7.0 Plot 05

7.1 Site Constraints & Considerations

7.3 Consultation Feedback & Responses

INITIAL FOOTPRINT

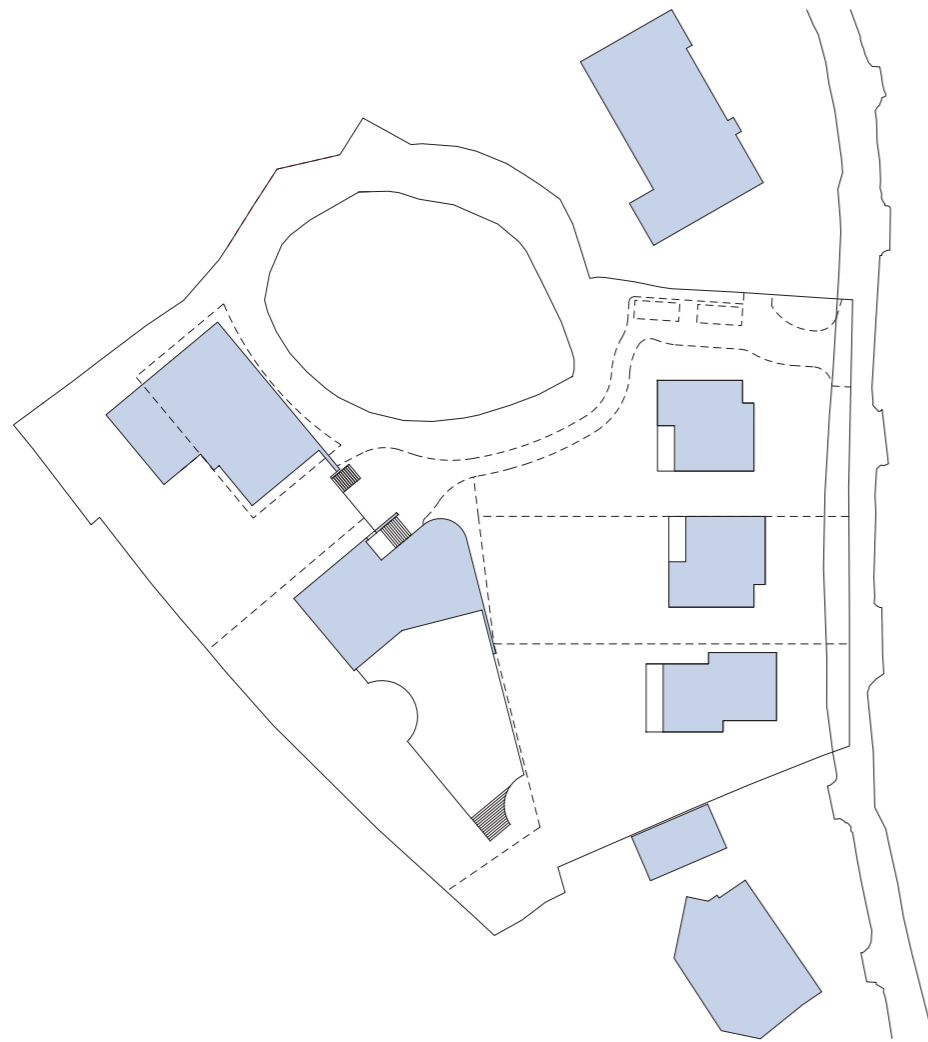
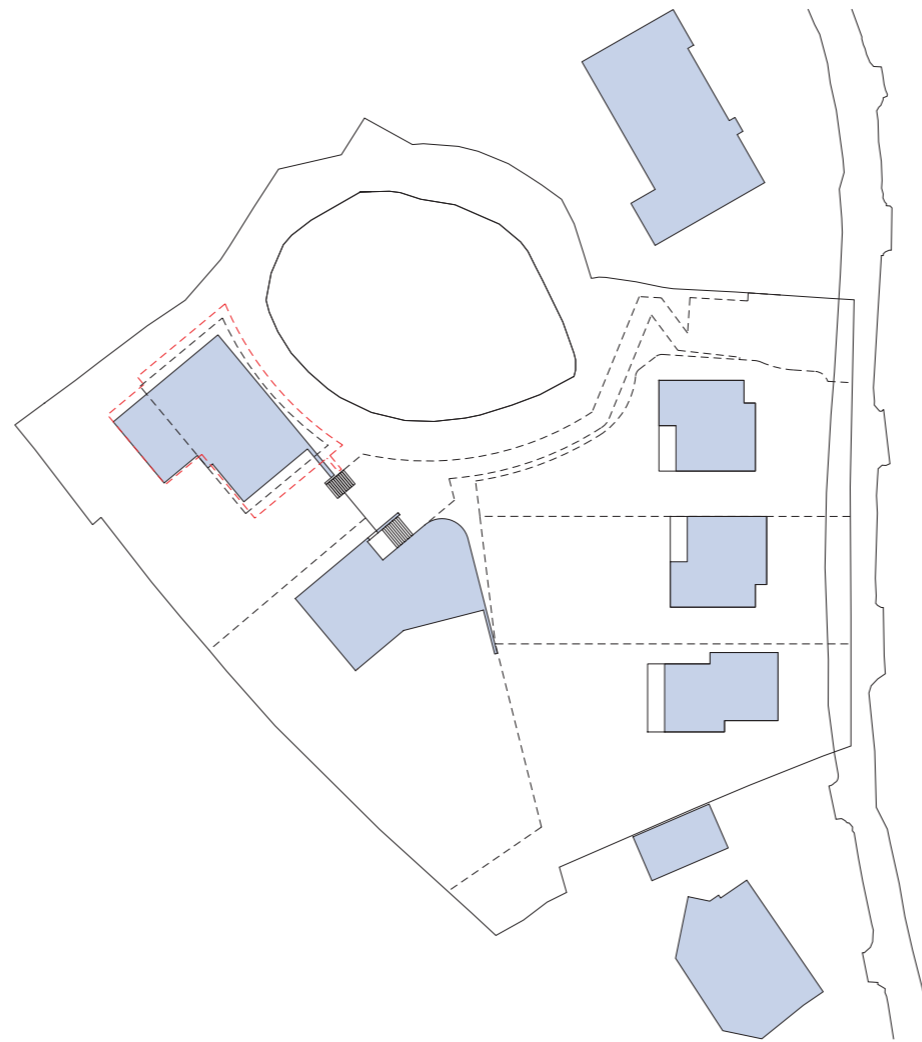
The design approach for Plot 5 has generally been supported by feedback received during the consultation process.

However, the size and proximity to the pond have been questioned.

POSITIONING & MASSING - DRP 01
 BUILDING FOOTPRINT POSITIONED 3.4M FROM
 EDGE OF POND - IN A SIMILAR POSITION TO THE
 EXISTING HARD TENNIS COURT

POSITIONING & MASSING - DRP 02
 FOOTPRINT POSITIONED 3.9M FROM EDGE OF
 POND (AT CLOSEST POINT).
 FIRST FLOOR OVERHANG POSITIONED 3.6M
 FROM EDGE OF POND

POSITIONING & MASSING - FINAL PROPOSAL
 FOOTPRINT POSITIONED 4.4M FROM EDGE OF POND (AT
 CLOSEST POINT).
 FIRST FLOOR OVERHANG POSITIONED 4.1M FROM EDGE
 OF POND
 REDUCTION IN GROSS EXTERNAL AREA BY 16%

REVISED FOOTPRINT

AREA REDUCED BY 16%
FOOTPRINT POSITIONED 4.1M FROM POND

The site plans adjacent indicate the revised size and position of Plot 5 in relation to the pond.
